Figure 1. Potential Hydraulic Energy from Inflows – Churchill River Basin

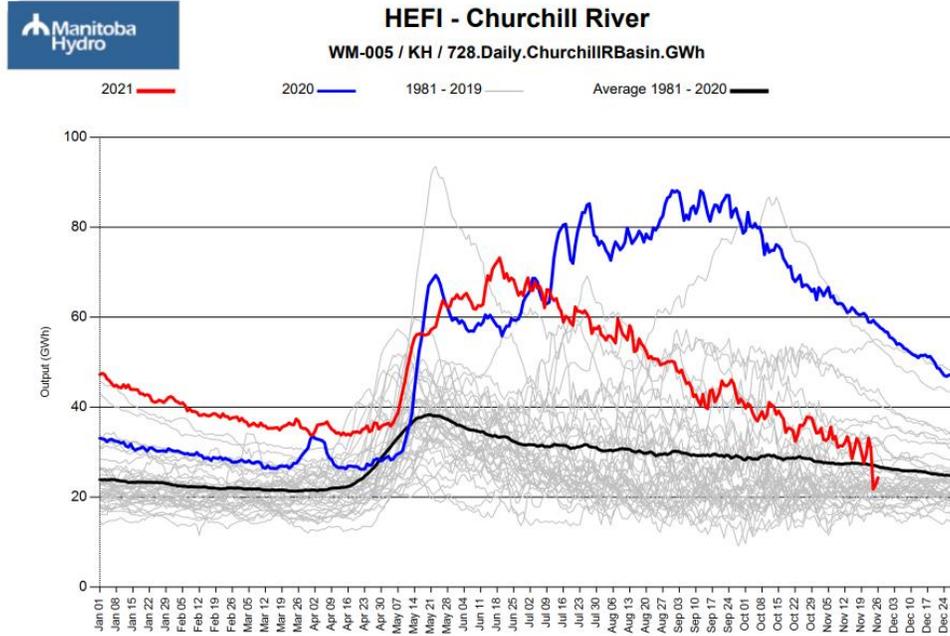
- a) Please explain how Figure 2, Energy from Inflow, and Figure 3, Energy in Storage, at page 12 of 51 of the Application take into account the addition of Keeyask (and, where relevant, pre-versus-post Limestone). Is the energy in storage from past years adjusted to reflect a consistent larger installed generation plant on the Nelson River? (i.e., what would the same quantity of water produce given the current plant installed?) Or is the data at each point in time reflective of the plant that was installed at that respective point in time?

Both Figure 2 (Potential Hydraulic Energy from Inflows) and Figure 3 (Total Potential energy in Storage) on page 12 of 51 of the Application were prepared assuming all hydraulic stations in the Manitoba Hydro system are in service, including Keeyask generating station, for all historic years shown.

Note that these charts reflect aggregate *potential energy*. The actual amount of hydraulic generation in any given flow year may be much less than these charts suggest because the ability of the Manitoba Hydro system to use all inflows and storage in the system is limited. Aggregate values, as opposed to specific inflow locations or reservoir storage levels, can mask details about how conditions can vary across the system.

The contrast of water conditions across the system has been very significant in the 2020-2021 period, where inflows on the Churchill River basin were well above average to near record high leading up to and during this period while southern portions of the system experienced drought conditions. Manitoba Hydro has been maximizing the Churchill River Diversion flows through this entire period, however a lot of water had to be spilled down the lower Churchill River and therefore not used for hydroelectric generation. For the period of April to early November 2021, over 4 Terrawatt-hours (TWh) of potential energy has been spilled. This amounts to about 15% of the projected total hydraulic generation for 2021/22 (26.4 TWh, reference Figure 10 of the Application).

Figure 1 below illustrates the potential energy from inflows for the Churchill River basin. This data forms part of the aggregate which is provided in Figure 2 of the Application. Figure 2 below illustrates the potential energy from inflows for the Winnipeg River basin which has experienced below average to record low inflows since early 2020.
